# Access Compliance Report

## Public Rights-of-Way

### (Curb Ramps)

Intersection ID: 9444	Main Street: JUDSON_AV	Cross Street: ZEBULON_AV	Location:	E
ADA ID: 32BE20D95800	Ramp Type: Para	Initial Pass/Fail: Fail	Overall Compliance: No	Severity Score: 12.5

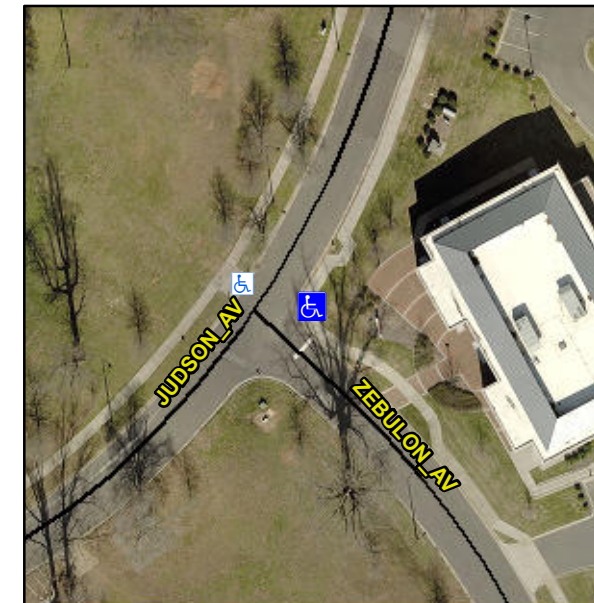
Surveyor Notes:

**RT RP < 5%**

PROW/ADA:

**R304.3.2**

Possible Solutions:

**Remove & Replace Entire Ramp.**
